# ICC A117.1 Comments on 2<sup>nd</sup> Draft

Proposal list to the 2017 A117.1 for the 2023 edition –  
03-30-2025  
Chapter 6

## CHAPTER 6 PLUMBING ELEMENTS AND FACILITIES

Figure C608.2.1.2(b)  
TRANSFER SHOWER WITH DRESSING ROOMS

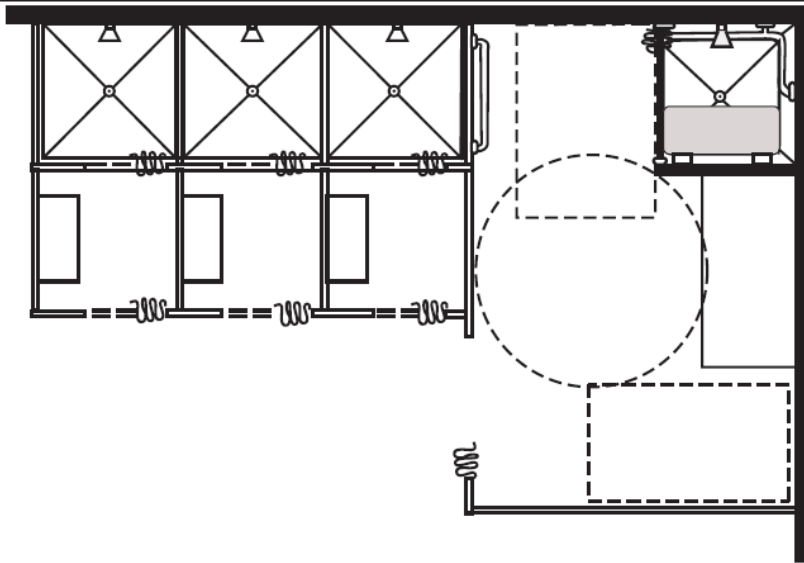
This figure is in the 2017 ICC A117.1 commentary.

**Committee Reason:** The modification brought forward is more technically accurate than the approved text. This will ensure that where there are changing spaces in front of shower stalls that this amenity will also be available for the accessible shower.

**FIGURE 612.2  
AMBULATORY ACCESSIBLE WATER  
CLOSET IN RELATION TO VERTICAL  
GRAB BAR OR STANCHION LOCATION**

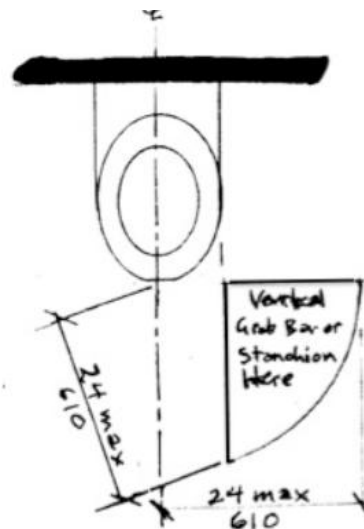
The Figure shows the grab bar or stanchion at the user’s left side but it could be on either side or both sides. Note 24 inches is the radius of the curved portion of the boundary within which stanchion or grab bar centerline is located.

The whole point of the major changes submitted for the A117.1 standard, especially in Section 612 of the plumbing chapter is to add one or two upper body points of control to the single weight-bearing foot, for example, (1) in entry to, using, and exiting from a bathtub or shower enclosure and (2) sitting down on or arising from a water closet. An increasing proportion of the population is in need of such aids if ambulatory people are to remain independently capable, as long as possible, of common activities of daily living without avoidable risks of injury-created disabilities, either temporary or permanent. As well as being a reasonable advance in public health in terms of injury prevention, it is a major quality of life benefit, the value of which greatly exceeds the cost of installing the stanchions and grab bars.

**FIGURE 604.4  
WATER CLOSET SEAT HEIGHT**

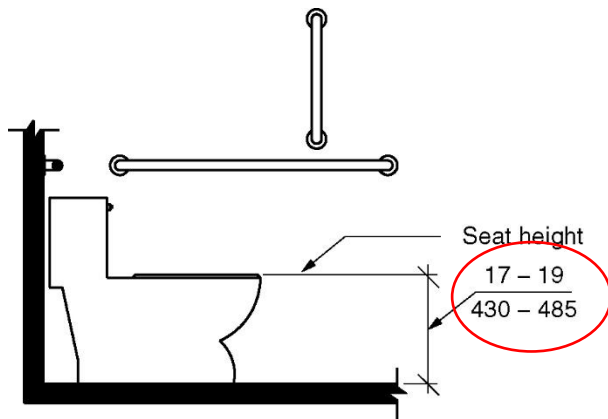
**604.4 Height.** The height of water closet seats shall be 17 inches (430 mm) minimum ~~and to 19~~ 20 inches (485 510 mm) maximum above the floor, measured to the top of the seat. Seats shall not be sprung to return to a lifted position.

(Note: Revise figure 604.4 to show 17-20)

~~**FIGURE 703.6.2.2  
SYMBOL FOR INJURED PERSONS**~~

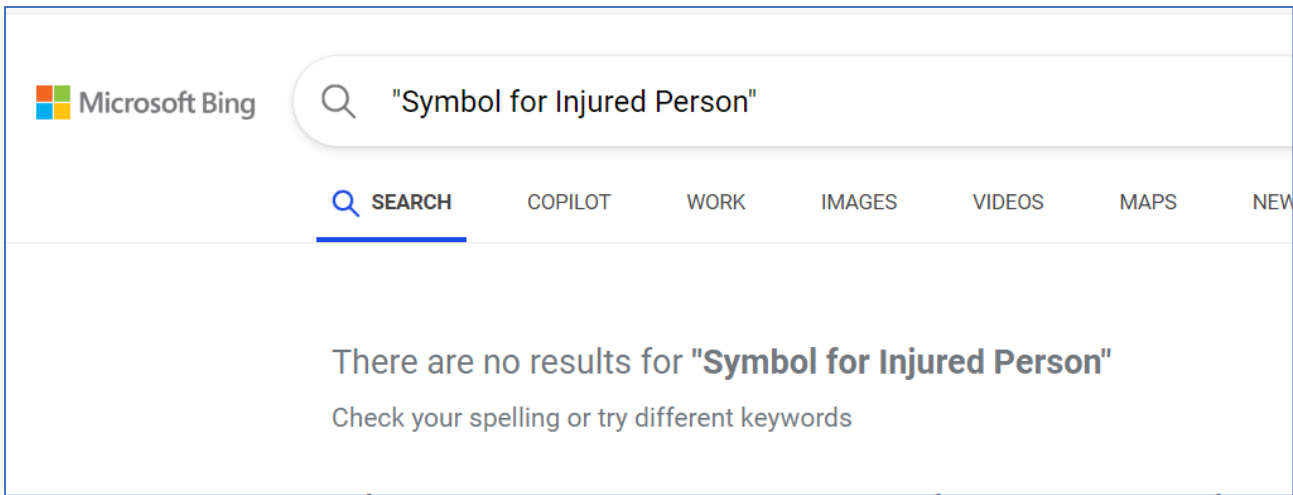
~~**703.6.2.2 Symbol for injured persons.** The Symbol for the Injured Persons shall comply with Figure 703.6.2.2.~~

**FIGURE 607.2(A)**  
**TRANSFER CLEARANCE FOR BATHTUBS WITH REMOVABLE IN TUB SEATS**

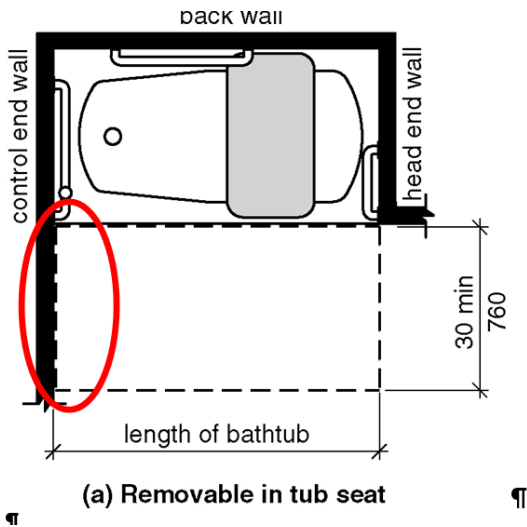
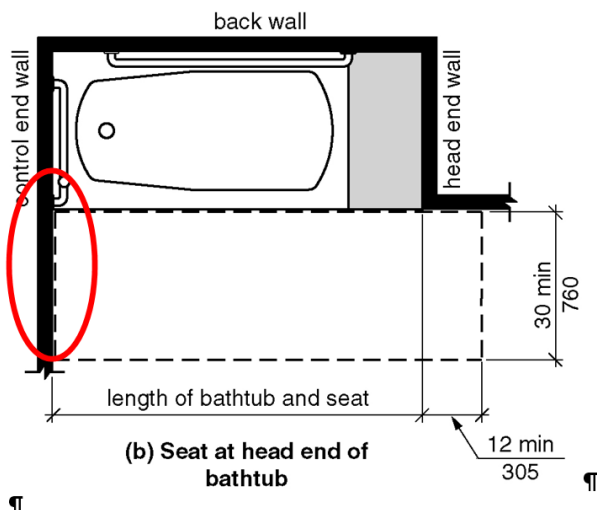
*Note: The wall in the Figures 607.2(A) and 607.2(B) would be jogged to indicate the additional 4 inch toe clearance in the new Figure 607.3. The committee will need to decide if Figures 607.2(A) and 607.2 (B) should be revised to show the control clearance with the transfer clearance or if the control clearance should be in a separate Figure 607.3. The figure submitted indicates the transfer clearance moving forward, not an addition 4 inch control clearance as the text indicates.*

**FIGURE 607.5**  
**LOCATION OF BATHTUB CONTROLS**

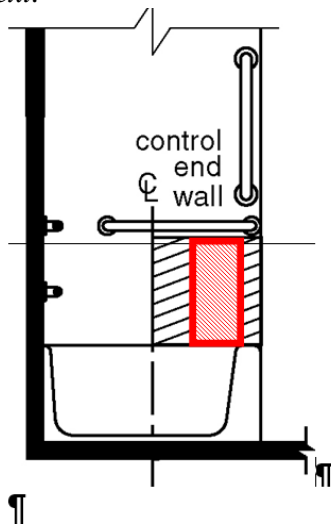
*Note: The area for the controls in Figure 607.5 would be revised to the smaller area indicated in the revised text.*

**Figure 1103.11.2.5.1(A)**  
**CLEARANCE FOR BATHTUBS IN TYPE A UNITS WITH REMOVABLE SEATS**

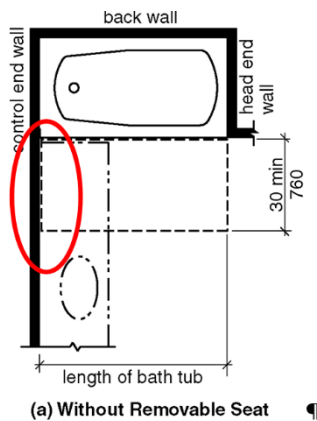
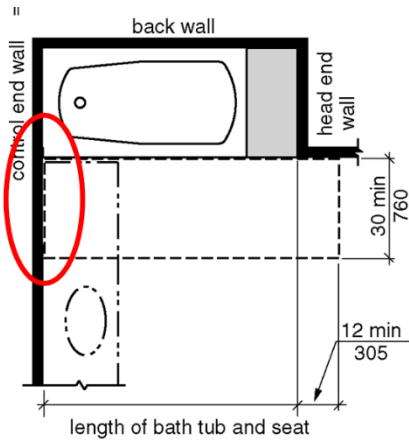
*Note: The wall in the Figures 1103.11.2.5.1(A) and 1103.11.2.5.1(B) would be jogged to indicate the additional 4 inch control clearance in the new Figure 607.2.1*

**FIGURE 607.5  
LOCATION OF BATHTUB CONTROLS**

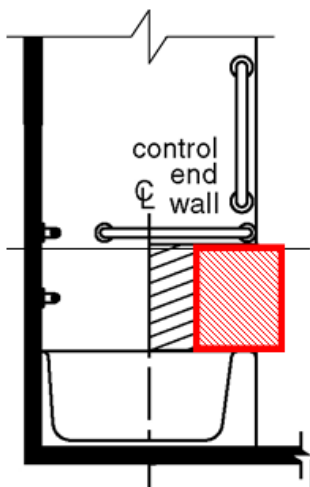
*Note: The area for the controls in Figure 607.5 would be revised to the smaller area indicated in the revised text. 9" is from the clear floor space, not from the front of the tub.*

**Figure 1103.11.2.5.1(A)**  
**CLEARANCE FOR BATHTUBS IN TYPE A UNITS WITH REMOVABLE SEATS**

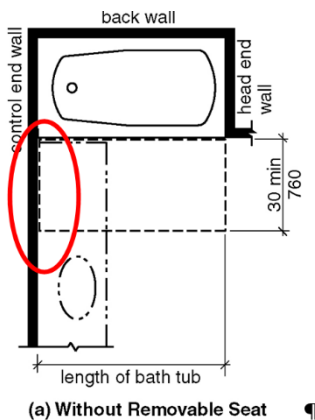
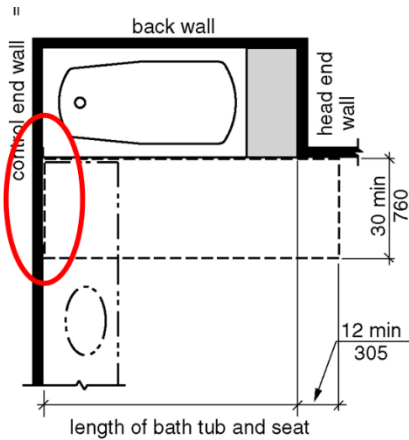
*Note: The wall in the Figures 1103.11.2.5.1(A) and 1103.11.2.5.1(B) would be jogged to indicate the additional 6-inch control clearance in the new Figure 607.3*

**FIGURE 611.7(B)**  
**ROLL-IN SHOWERS FOR ASSISTED BATHING**  
**OPTION 2**

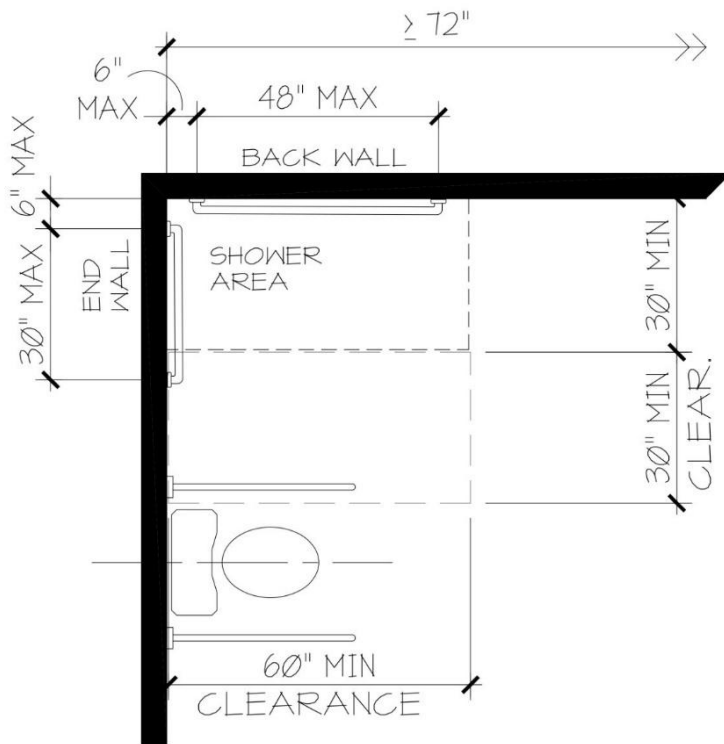
Figure should show grab bars as 48" minimum and 30" minimum.

**Committee Reason:** This change incorporates other changes approved for bathing. The revisions adds clarity. There was a question about Section 611.5.3 Exception 1 – however the strength requirements is only a safety feature for a towel bar; the towel bar does not serve as a grab bar. The minimum and/or maximum on the grab bar lengths needs to be clarified in Figure 611.7 – have editorial look at this.
